Product hierarchy no. *				Part no.	SBU	Type / Description	Customer part no.
SBU	PG	PGU	Type				
02	005	012	0000001150	See list below	Power Entry Mod. w/o F.	Fusedrawer 2	n.a.

Product Change Notification					PCN Fusedrawer 2		
owner	creation date	release date	released by	change order no	rev	page	D10-017-137
bachmajo	15.11.2017	16.11.2017	limachcl	2014163	D	1 of 3

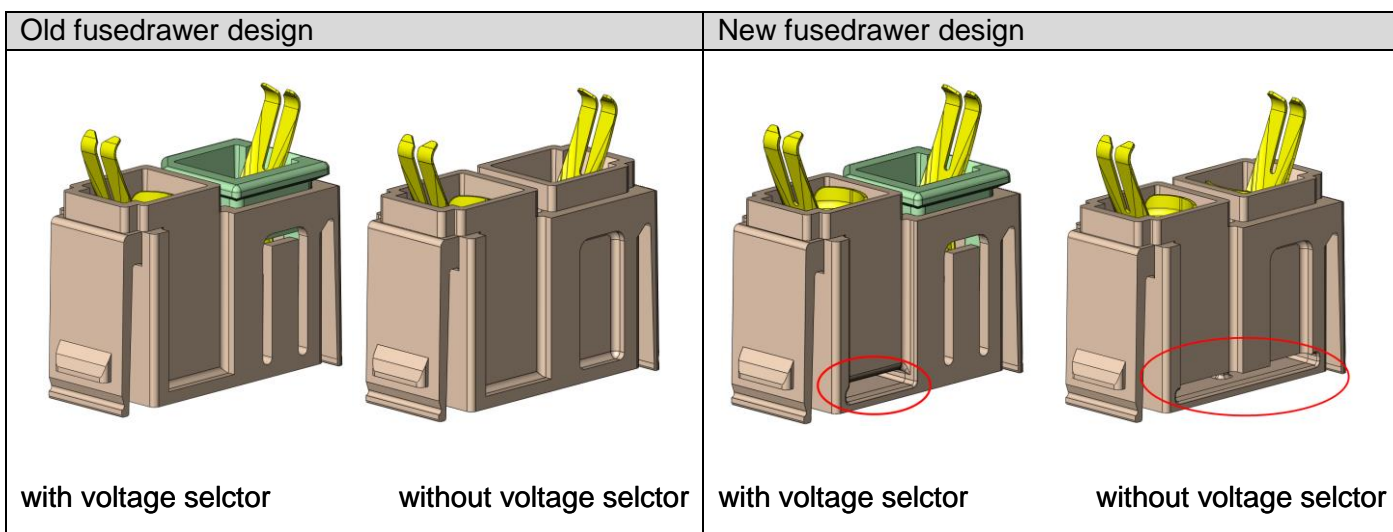
Change of plastic material from PBT+PC to PBT (Fuseholder and voltage selector)

Change of fusedrawer design (additional air gap)

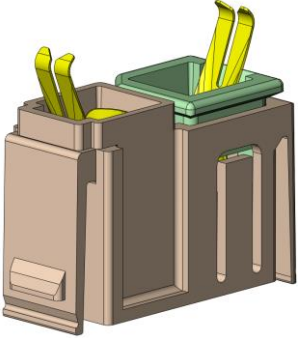
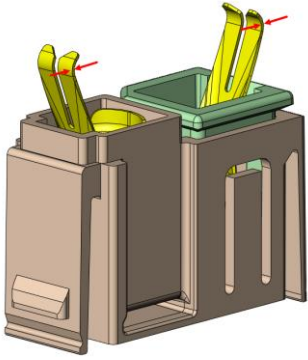
Old contact spring thickness 0.20 mm	New contact spring thickness 0.25 mm

Old voltage selector insert white	New voltage selector insert changed to black colour

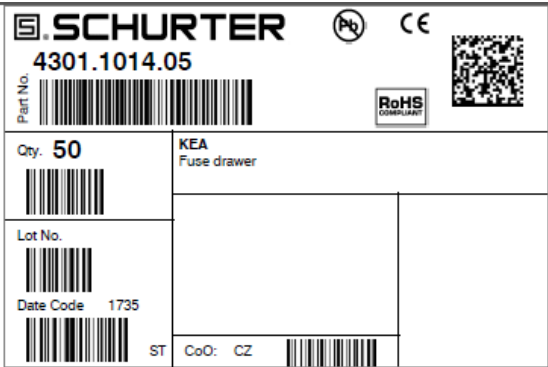
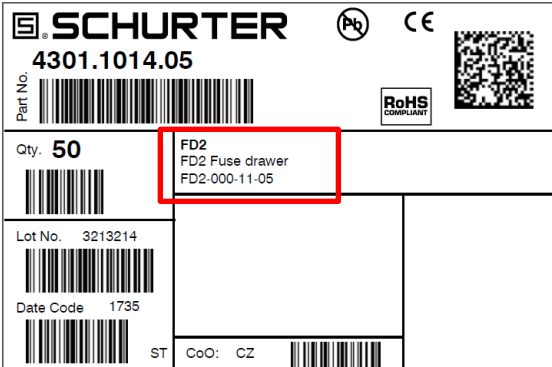
Old label	New label
	<p>Name and description adjusted. Configuration code added.</p>
